Location Address: 2351 THOMAS STREET, HOLLYWOOD, FL 33020
Lot(s): 10 W 7.75, 11,12 Block(s): 37 Subdivision: HOLLYWOOD PARK
Folio Number(s): 5142 09 05 6120

TO THE CITY OF HOLLYWOOD
DEVELOPMENT SERVICES - PLANNING DIVISION
TECHNICAL ADVISORY COMMITTEE REPORT – RESPONSE LETTER
COMMENTS AND **ANSWERS IN RED**

SUBJECT: Preliminary Site Plan and Design review for 18 Residential Units.

1 SIGNAGE DETAILS
1" = 1'-0"

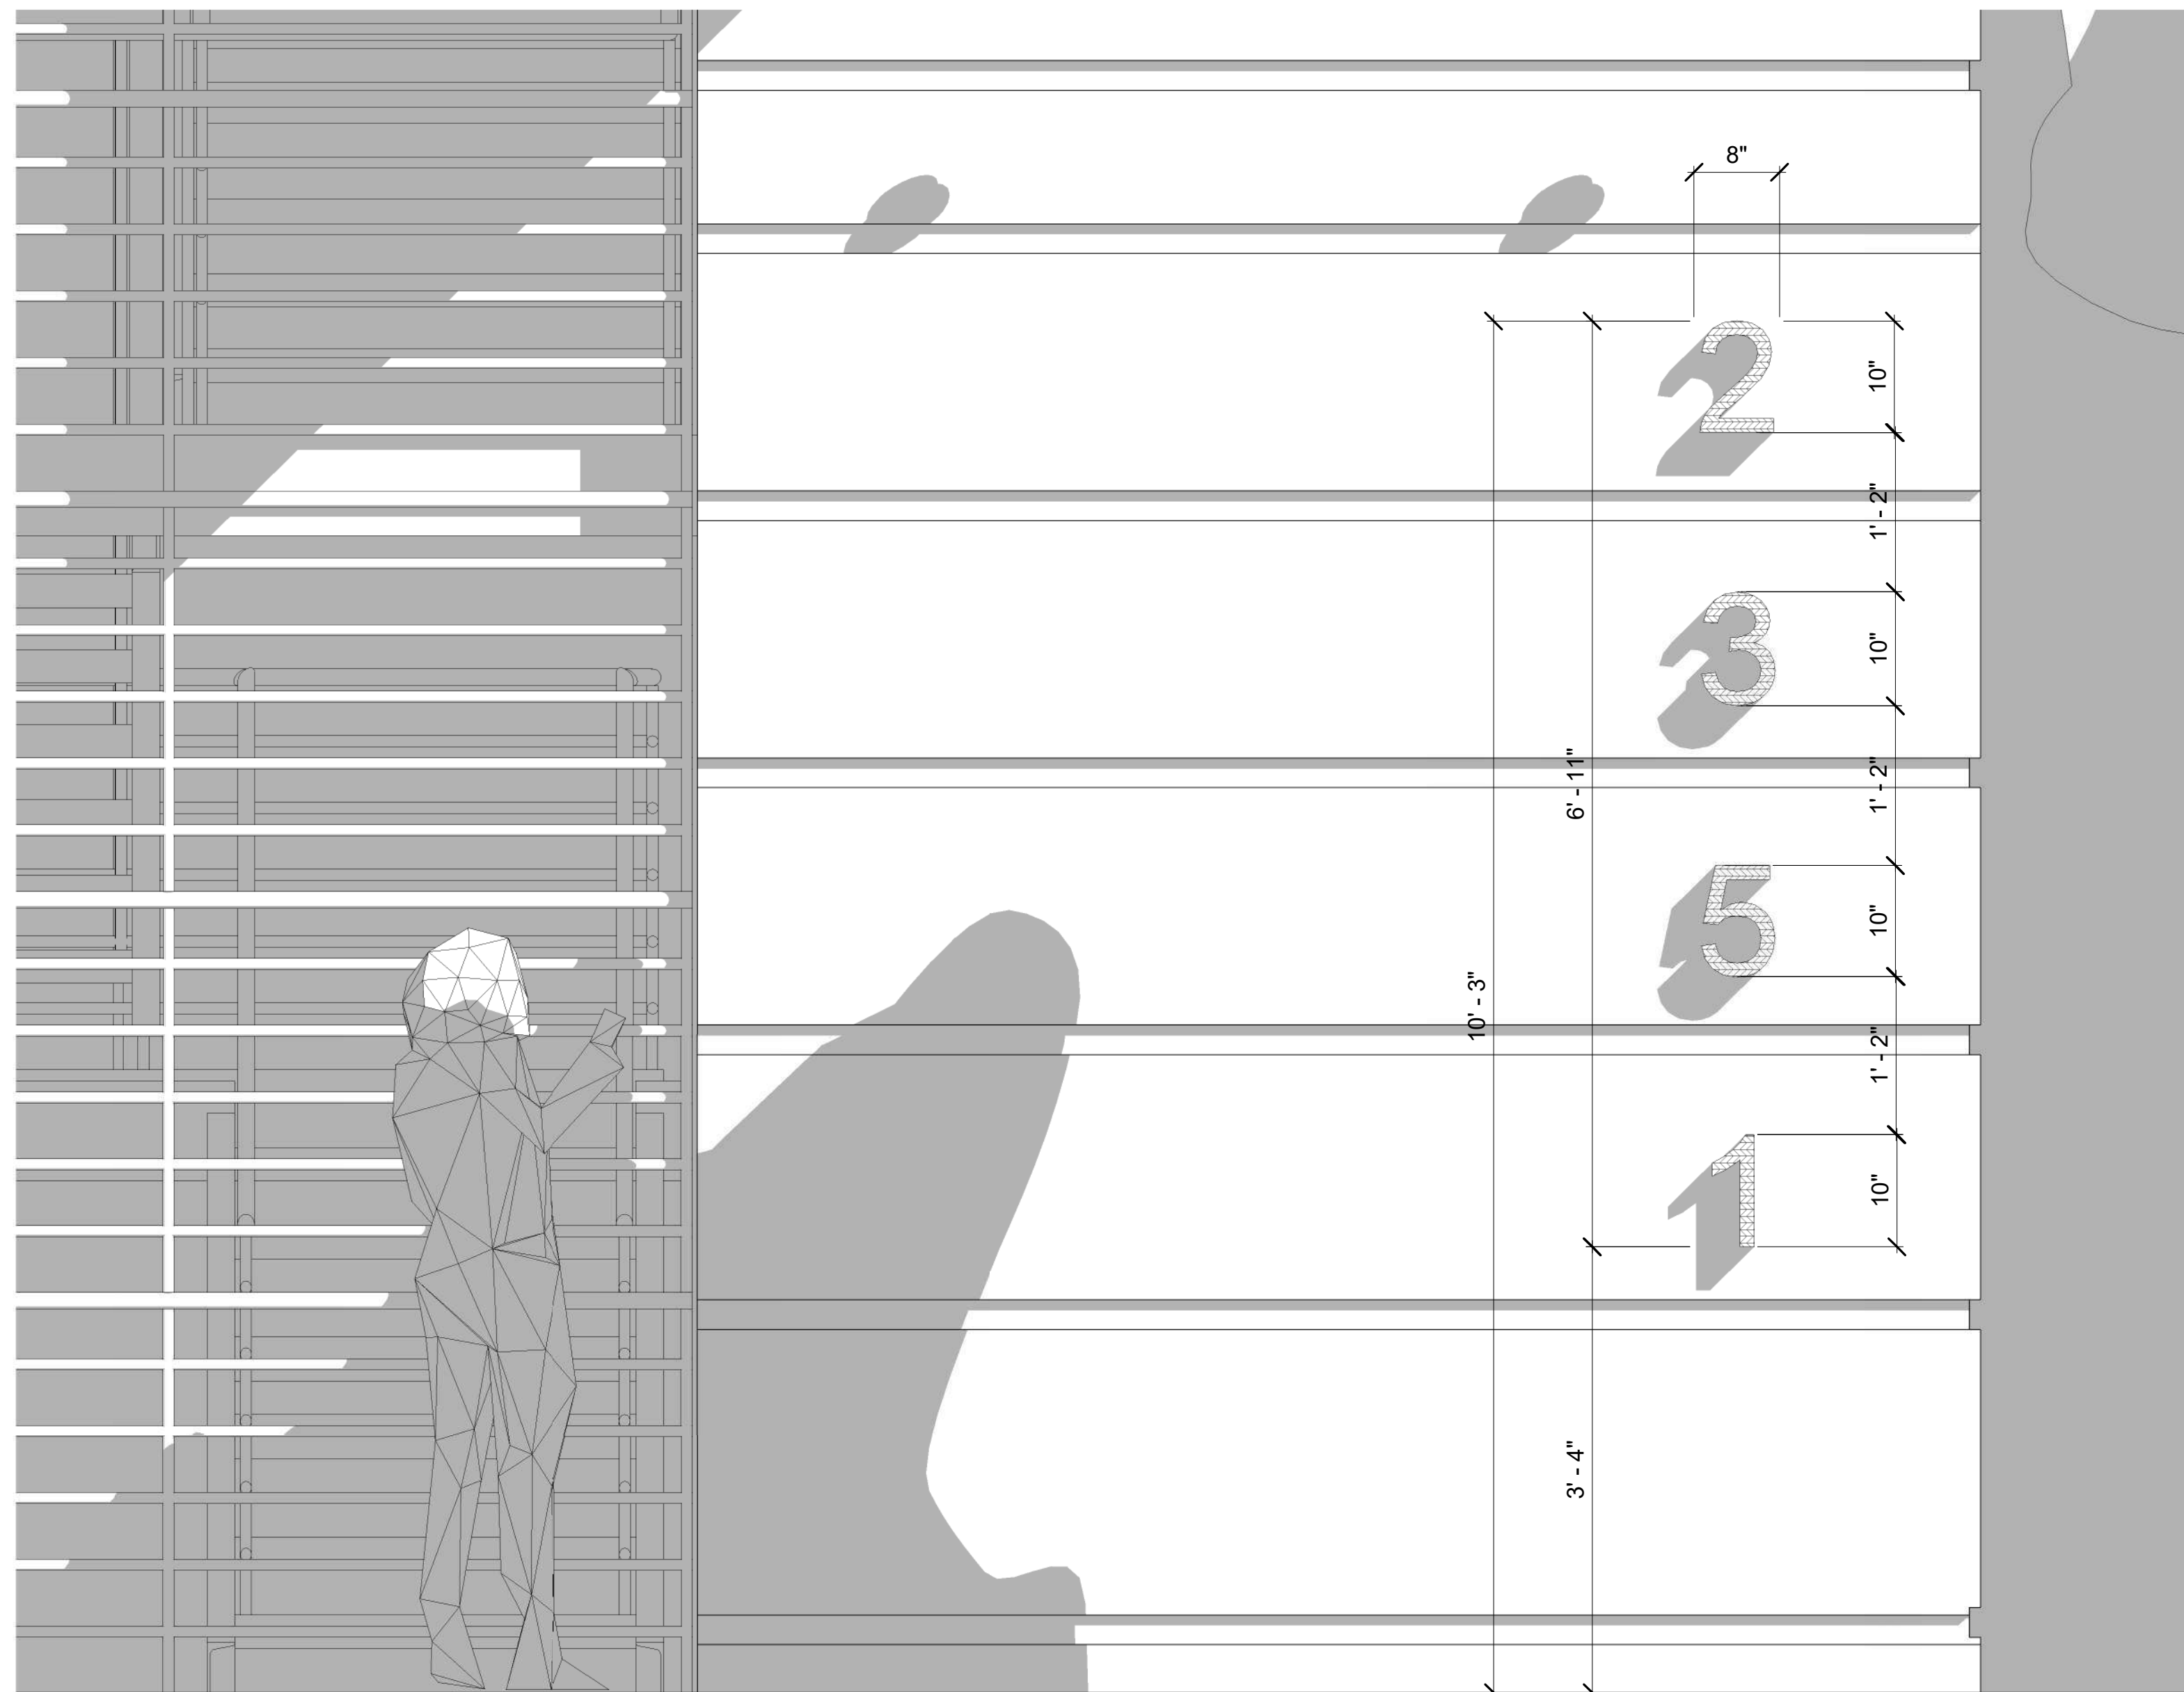
1. For review, full signage package shall be provided. **R. SIGNAGE DETAILS PROVIDED AT NEW SHEET A1.5. THE SIGNAGE IS UNDER A SEPARATE PERMIT, WHEN FULL SIGNAGE PACKAGE WILL BE PROVIDED.**

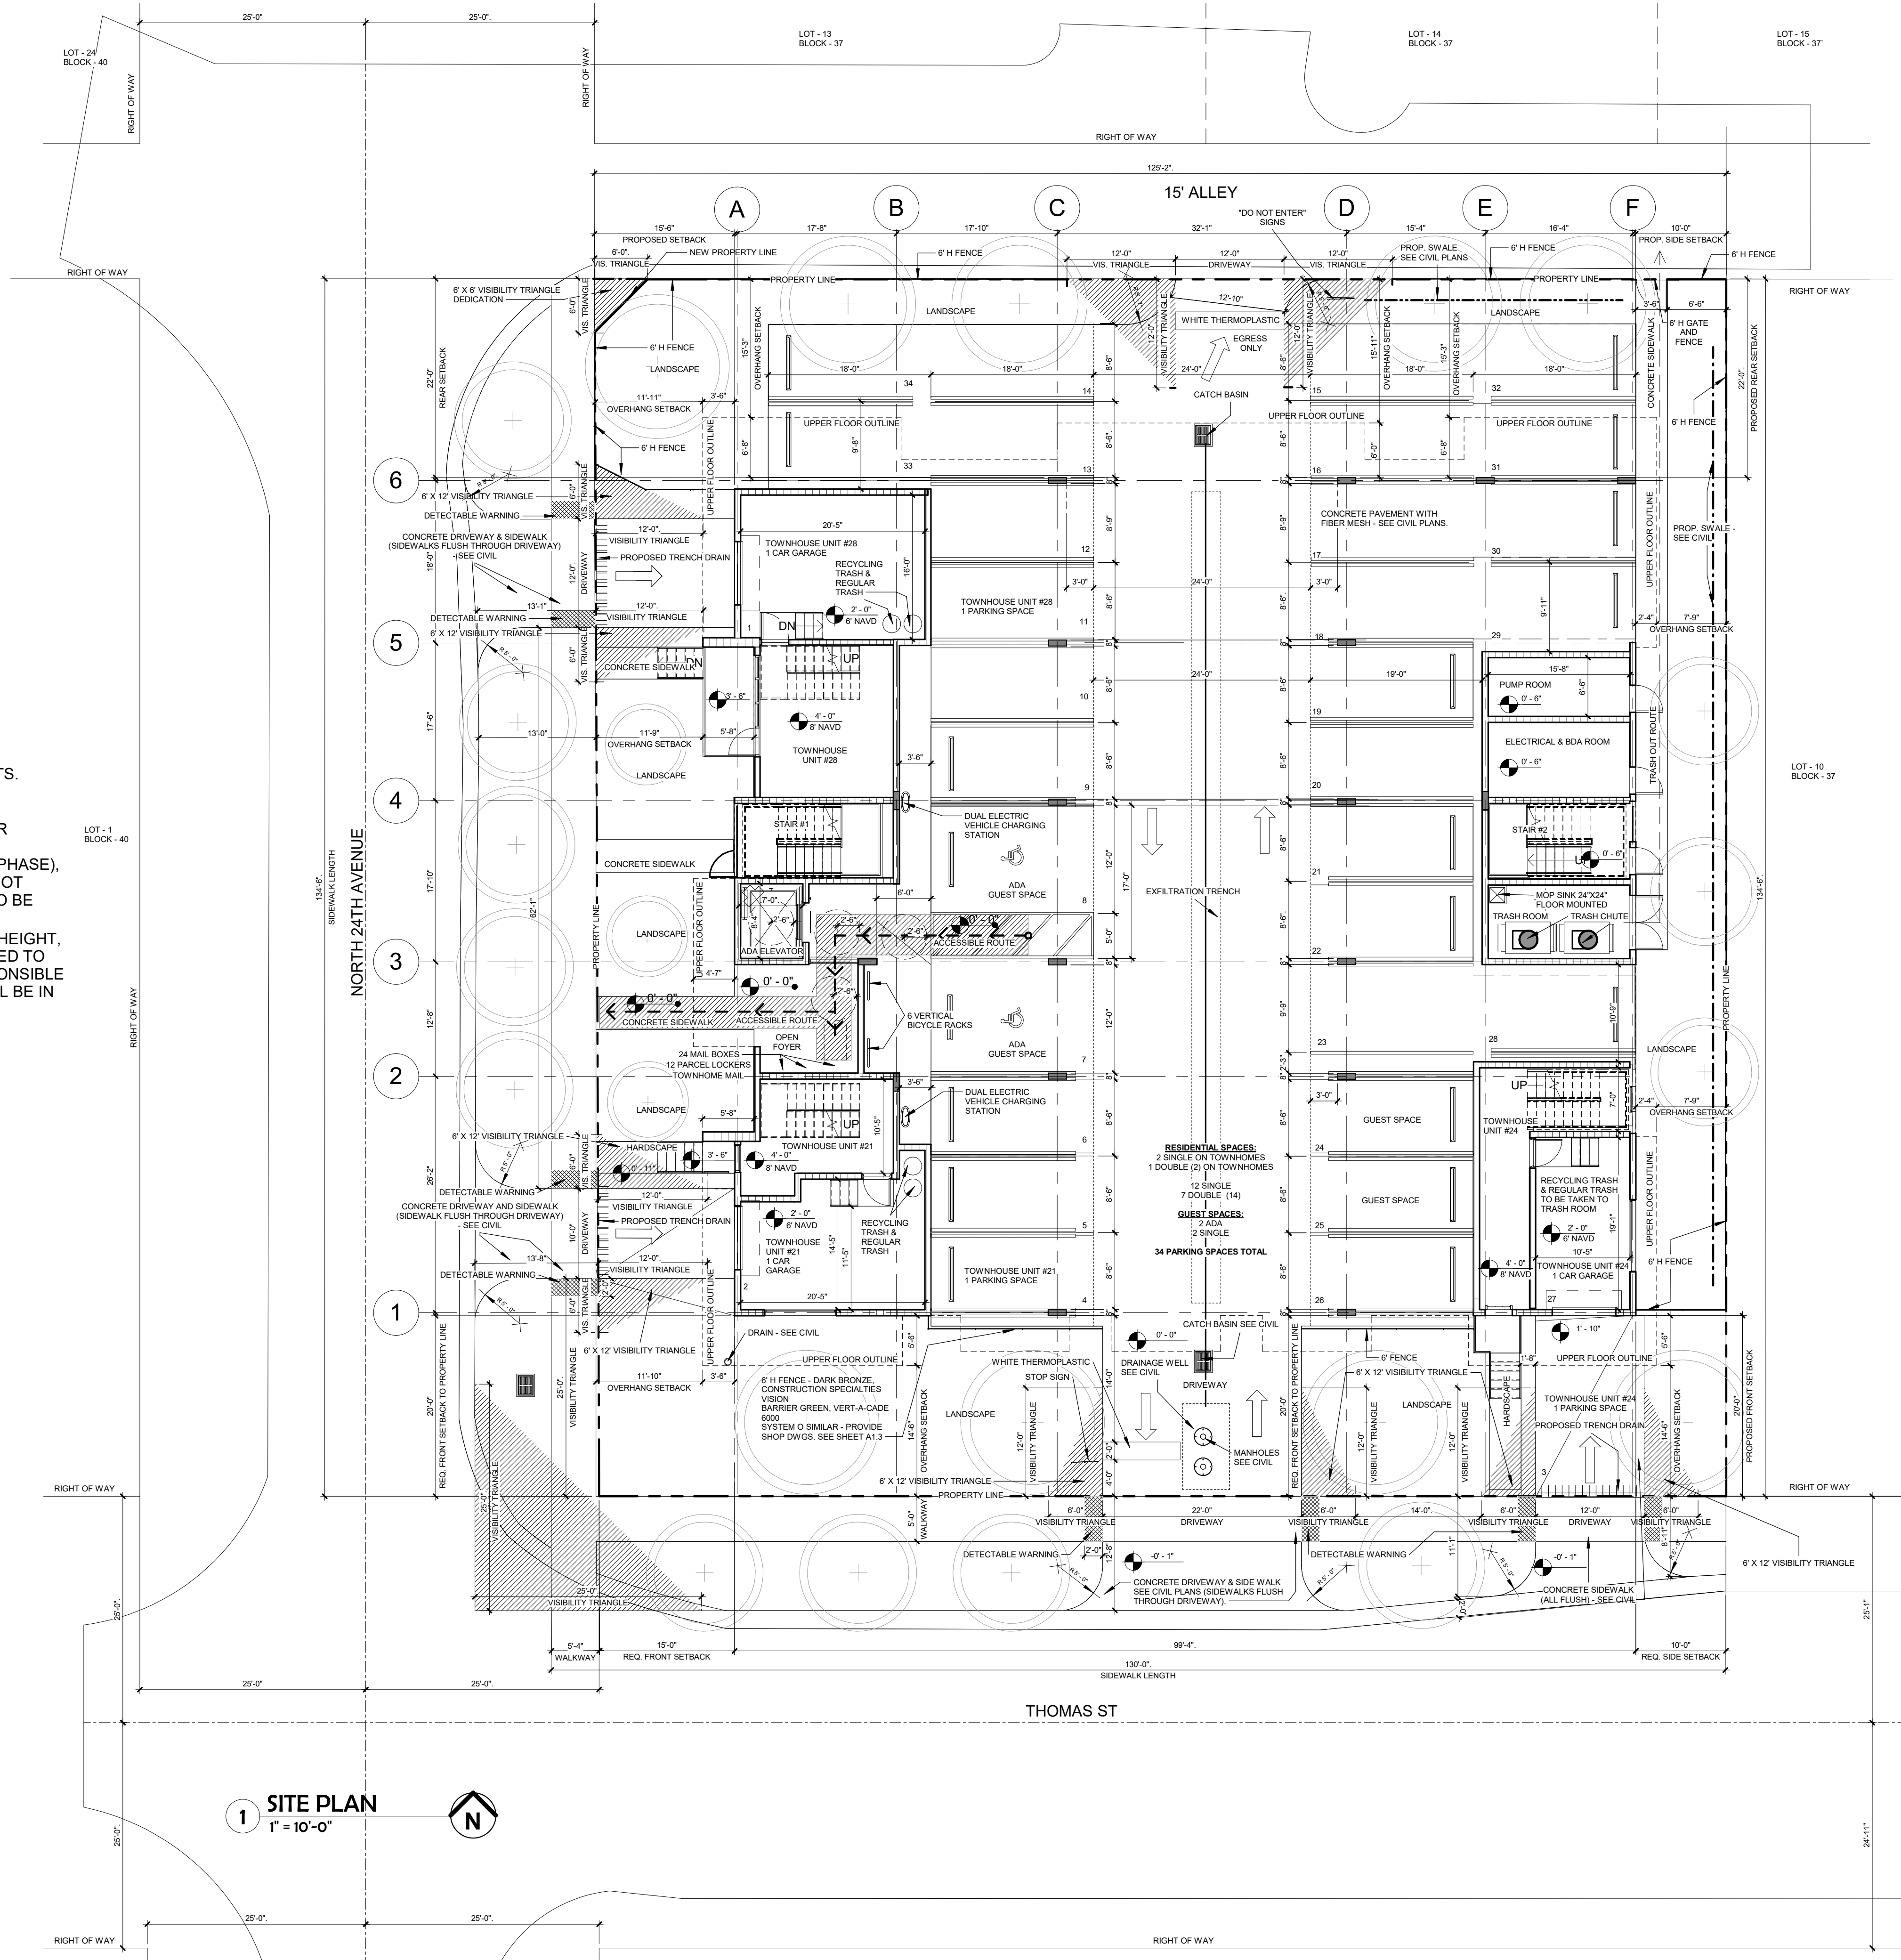
4. Site Plan:
 - a. Two-way traffic drive aisle shall be a minimum of 22'. **R. NOTE SITE PLAN, SHEET A1.0. TWO-WAY TRAFFIC DRIVE AISLE IS 22'.**
 - b. Provide dimensions of the garages and indicate if two or one car garage. **R. NOTE SITE PLAN, SHEET A1.0. ALL GARAGE DIMENSIONS ARE DISPLAYED.**

- c. Show dimensions of sight triangles. **R. NOTE SITE PLAN, SHEET A1.0. ALL SITE TRIANGLE DIMENSIONS ARE DISPLAYED.**
 - d. Show corner setback triangle at 25'. **R. NOTE SITE PLAN, SHEET A1.0. CORNER SETBACK AT SOUTH WEST SIDE.**

- e. Ensure that the bicycle racks are not positioned within the 25' corner setback triangle. **R. NOTE SITE PLAN, SHEET A1.0. BICYCLE RACKS ARE ALOCATED AT THE PARKING LOT, RIGHT IN FRONT OF THE COMMOM AREA ON THE WEST SIDE.**

- f. Show walkway setbacks and dimensions. Walkways shall be setback a minimum of 3' from the property line. **R. NOTE SITE PLAN, SHEET A1.0.**
 - g. Show and indicate curbing type for at-grade parking. **R. NOTE SITE PLAN, SHEET A1.0 AND CIVIL PLAN, SHEET C-2.**

- h. Tandem parking shall be allocated to one unit. As a result, parking is short the required 4 guest spaces. **R. NOTED. ONLY 2 GUEST SPACES ARE REQUIRED AND PROVIDED AS SEEN ON SHEET A1.0 – SITE PLAN.**

- i. Show dimension of egress only curb cut. **R. DIMENSION OF EGRESS SHOWN AT SHEET A1.0 – SITE PLAN.**
 - j. On Sheet A2.2, it appears the upper left unit is not accounted for. Continue unit count for accuracy. **R. UPPER LEFT UNIT IS ACCOUNTED NOW AS UNIT #30 ON SHEET A2.2.**

1. Note maximum foot-candle level. **R. PLEASE SEE NOTE NUMBER 1 AT SITE PLAN, SHEET A1.0.**
